MEMORANDUM

Subject: SLUP 25-02 – 125 Perimeter Center West, Parcel ID# 18 349 05 002

Zaxby's Properties, LLC requests a Special Land Use Permit for a drive-through to allow the construction of a new drive-through restaurant.

Image 1, Recommended crosswalk

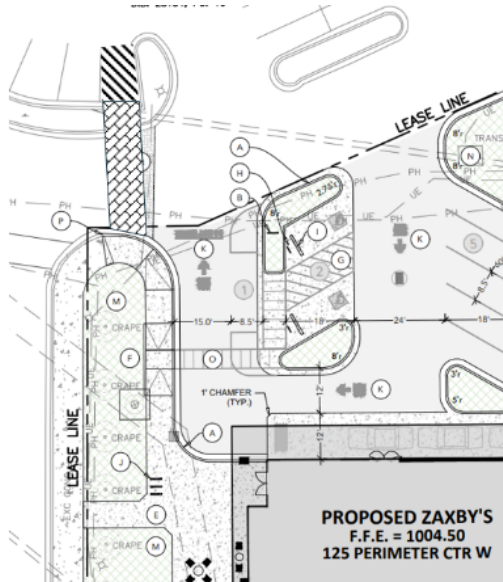
Pedestrian access is provided from Perimeter Center West via a staircase, from the sidewalk at the entrance drive, and from the shopping center's main parking lot via a crosswalk. Staff recommends that the crosswalk be designed to match an existing crosswalk at the adjacent parking lot at 123 Perimeter Center West (see Image 1 & 2).

2. The crosswalk labelled as “Q” in Exhibit A shall be a raised crosswalk.
3. The outdoor patio area, labelled “T” in Exhibit A, shall be equipped with outdoor heaters to allow year round use of the space.
4. If the initial operator, or any future operator of the building, requires a modification to the building that results in an increase of square footage of the primary structure and/or a modification to the drive-through stacking lanes, then a new Special Land Use Permit will be required.

Image 3. Easement shown in red

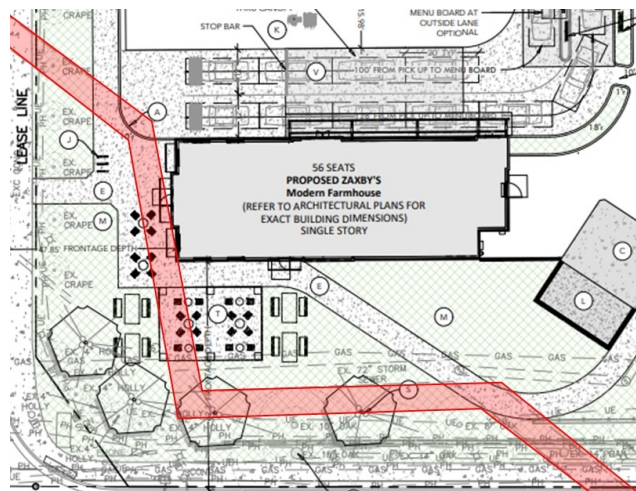
The proposed building is setback 53 feet from Perimeter Center West. Although the OCR district has a 0-foot street setback, it is not possible to construct a building at the street because of a 72" stormwater pipe that runs along the front property line. A building cannot be constructed atop the stormwater pipe (see Image 3), but the space will be used for landscaping and outdoor seating. The outdoor seating area shall have heaters to allow year-round use of the patio.

SHEET NUMBER:
C 3.0

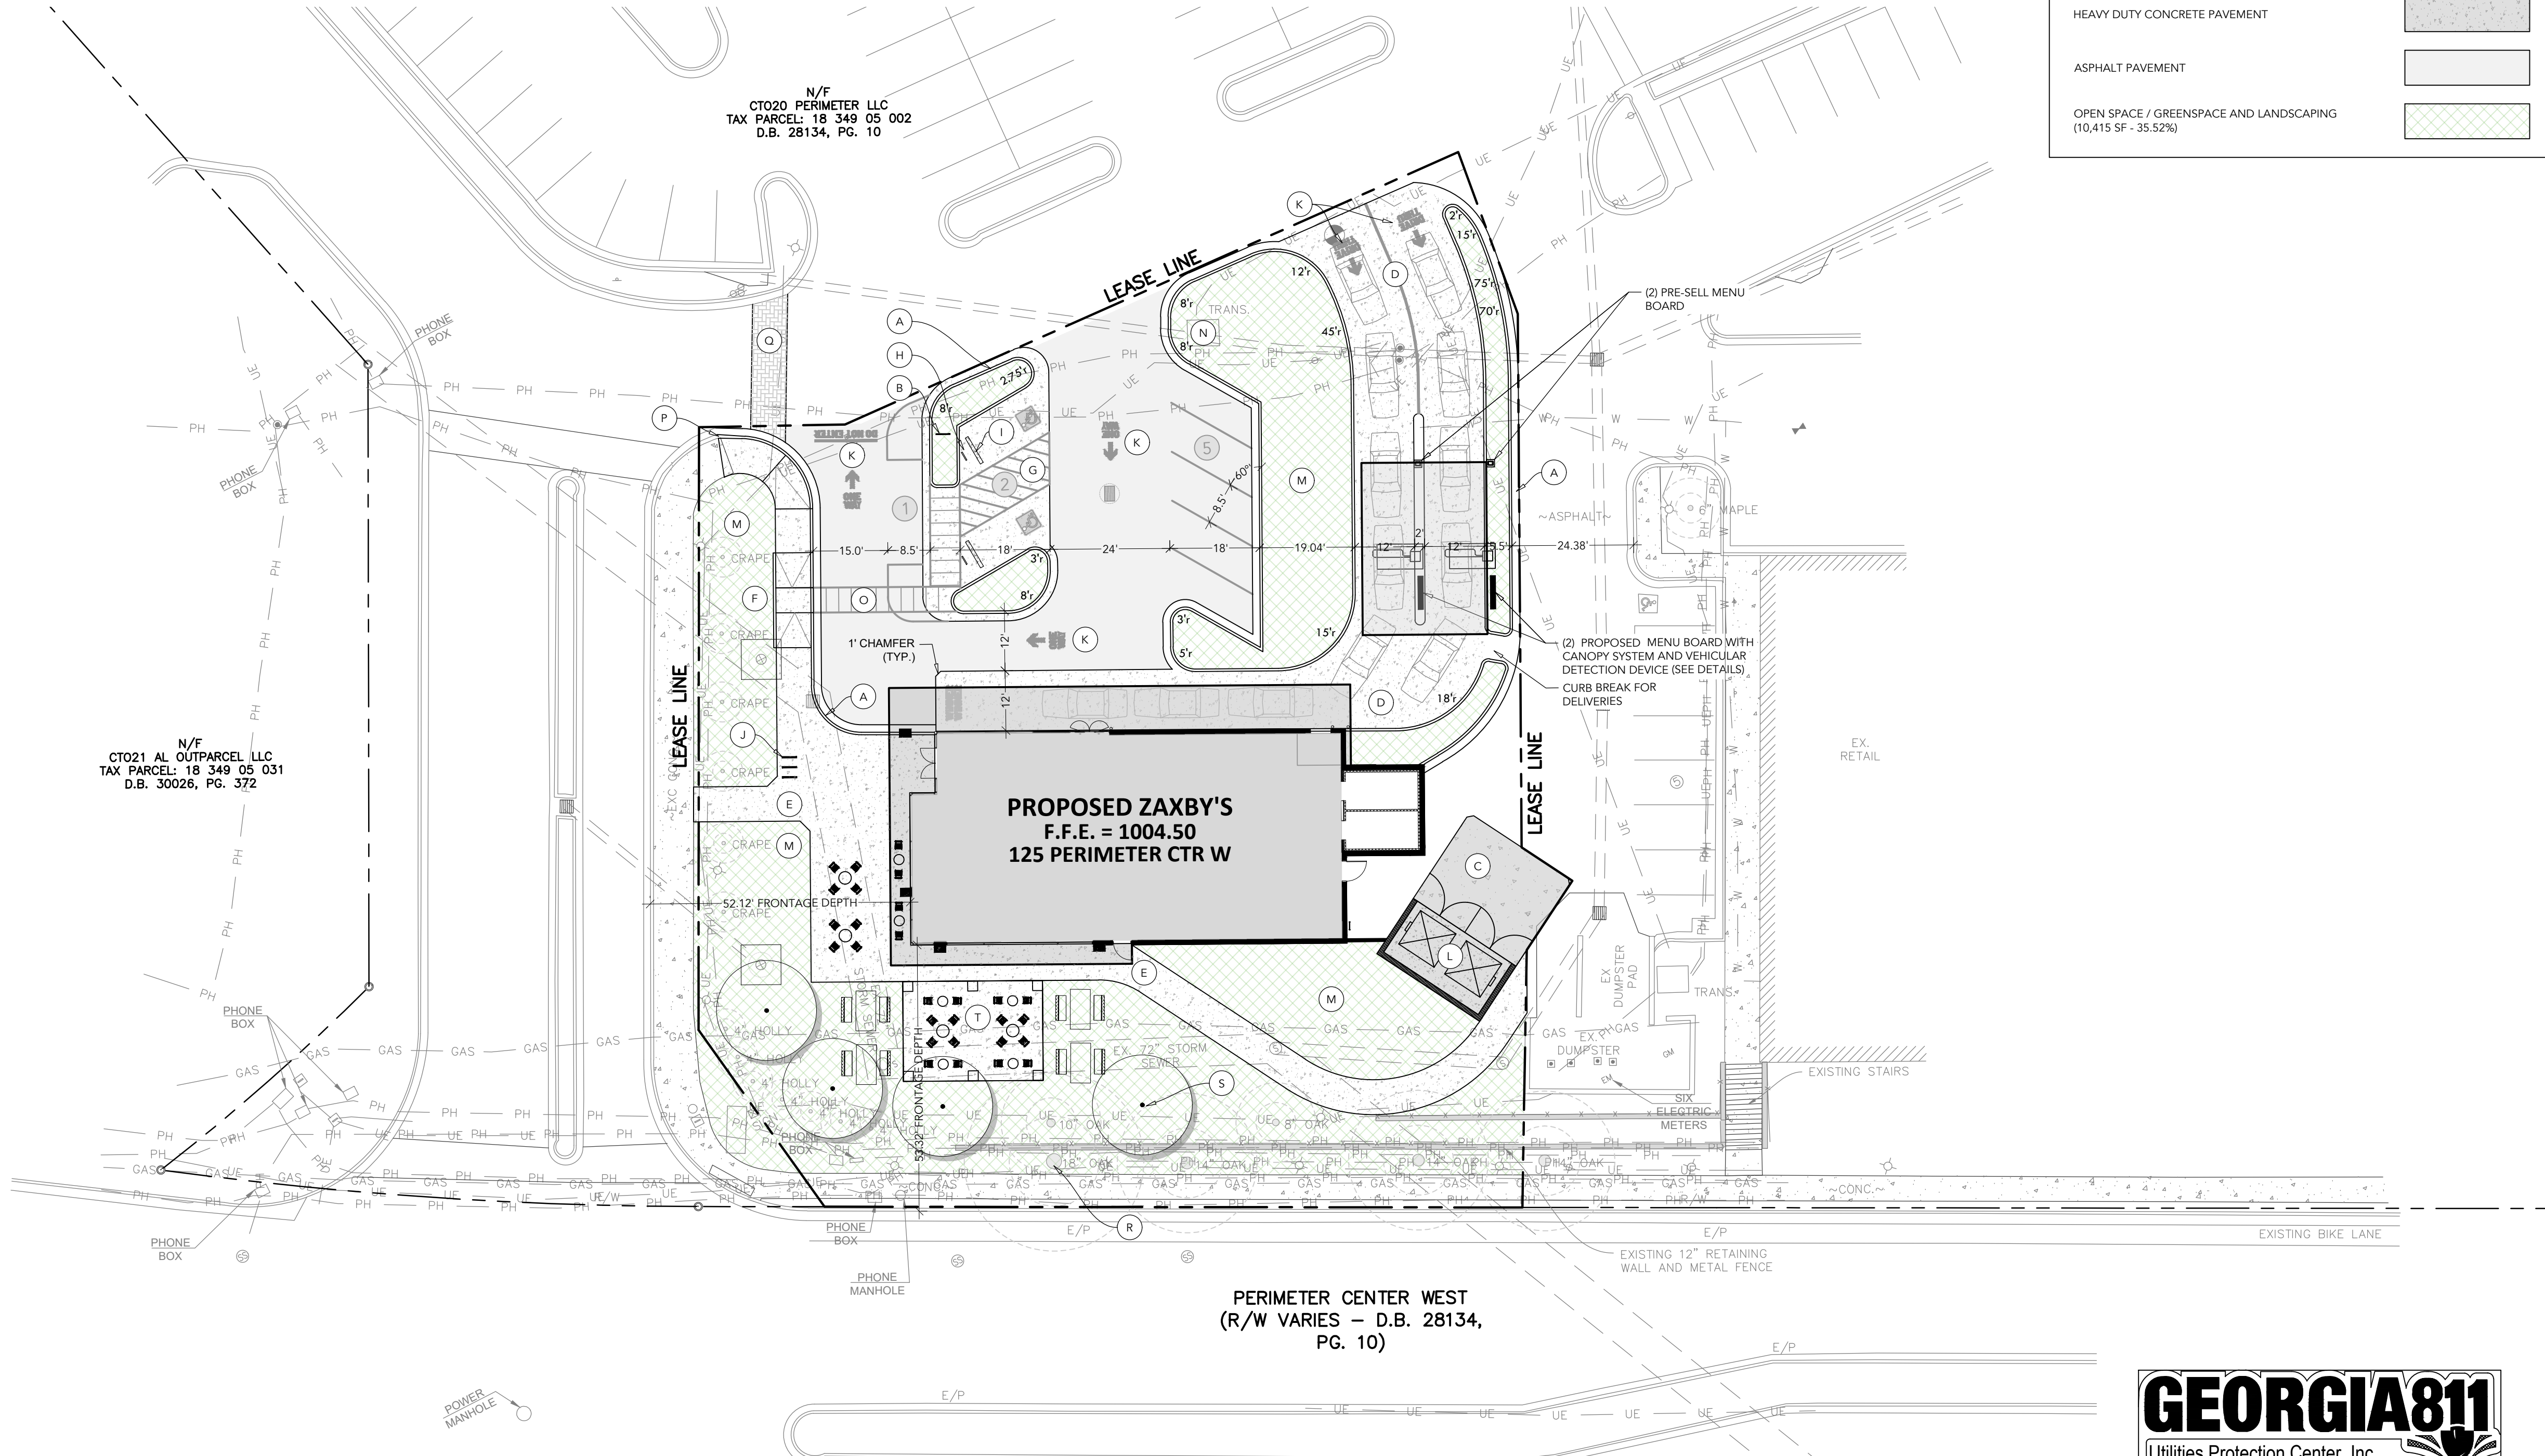
- **Updated Site Plan, Elevations, and Renderings**
 The site plan is functionally similar to the previous version; the main difference is the footprint of the building which reflect the changes made to the building. The applicant has also submitted updated elevations that are a significant departure from the building that was reviewed by the Planning Commission. Staff recommends that the updated application be referred back to the Planning Commission.

- **Updated Site Plan**
 The drive through lanes were reconfigured to allow additional stacking; capacity increased from 13 cars to 18 cars. The additional capacity was added by extending the second drive-through lane. This extension required the reconfiguration of the parking lot and 4 parking spaces were removed. Other changes include additional sidewalks and crosswalks for pedestrian circulation along the northern lease line.
- **Queuing Analysis**
 The queuing, i.e. stacking capacity, was analyzed using data from a Zaxby's location in Brookhaven. The analysis concludes there is adequate stacking space to accommodate traffic during peak hours.

Drawing No:
A1.0

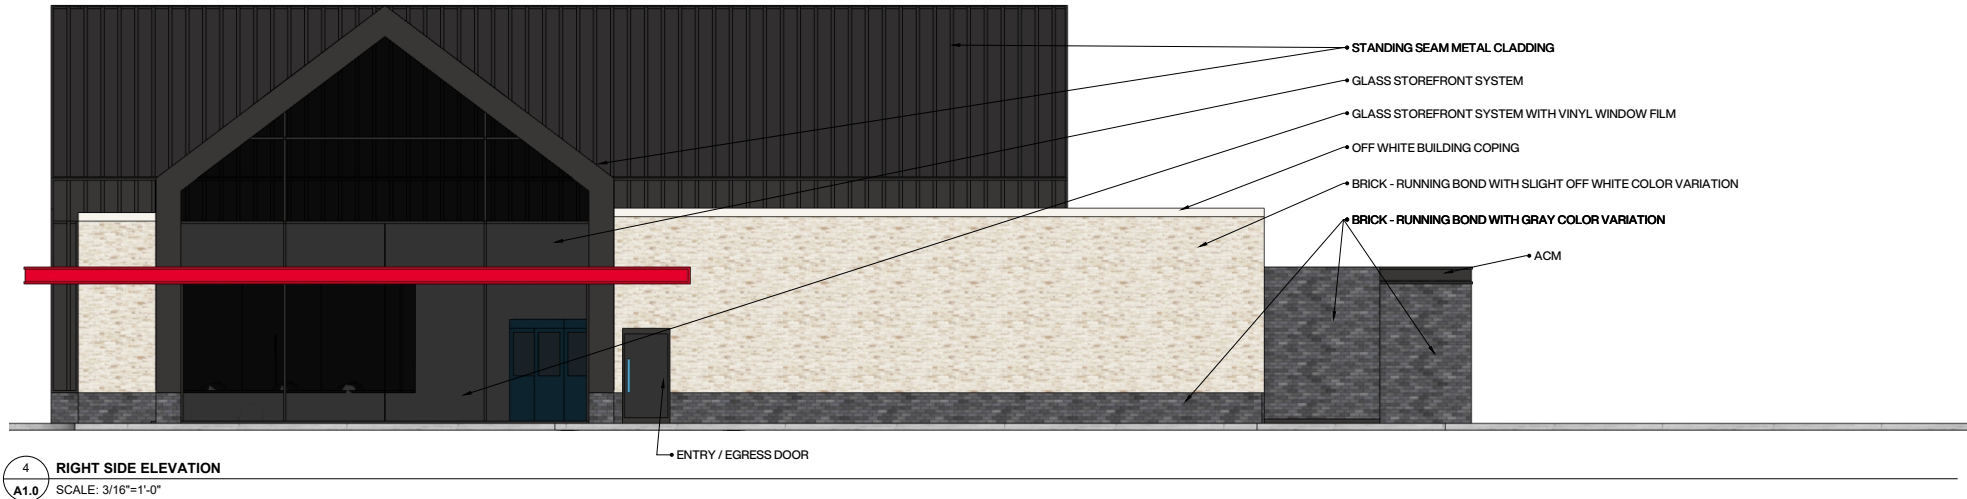
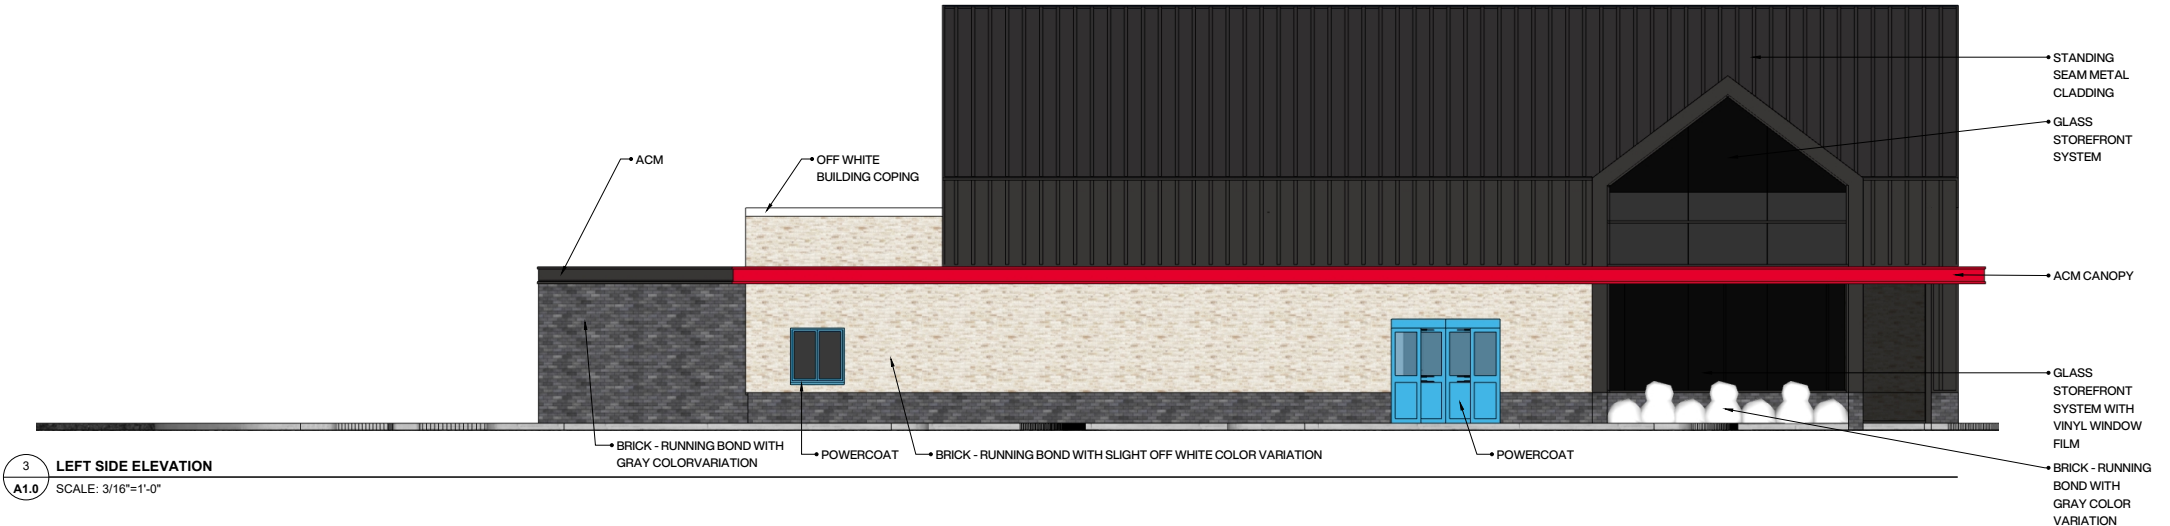
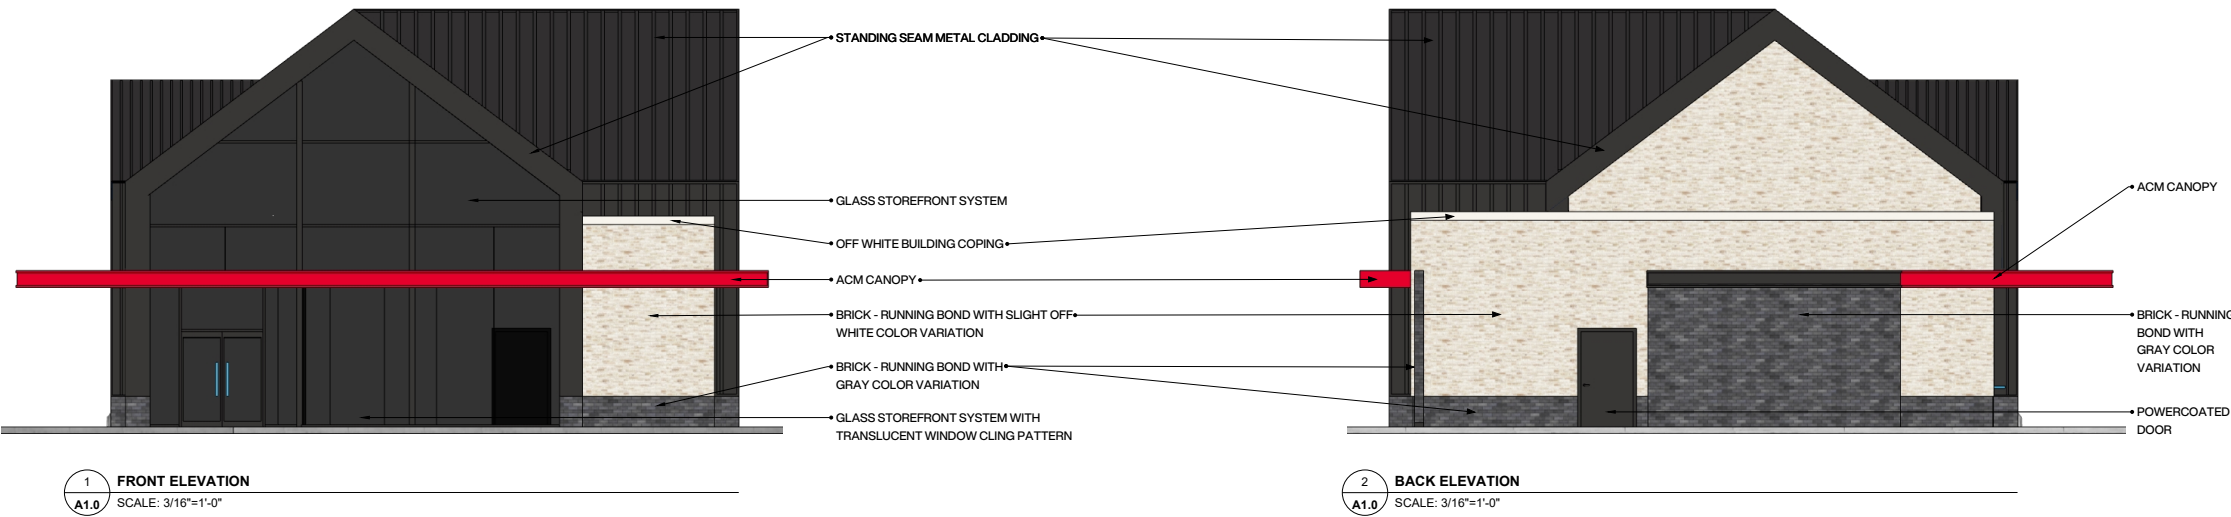
The major façade materials are brick and glass, with a parapet roof. The color palette is mainly neutral to match the surrounding buildings. The proposed materials are consistent with the requirements for the Perimeter Center but the design is a significant departure from what was proposed at Planning Commission, which included a higher ratio of glazing and an articulated roof.

Staff recommends that updated application be referred back to Planning Commission for review, due to changes to the elevations.
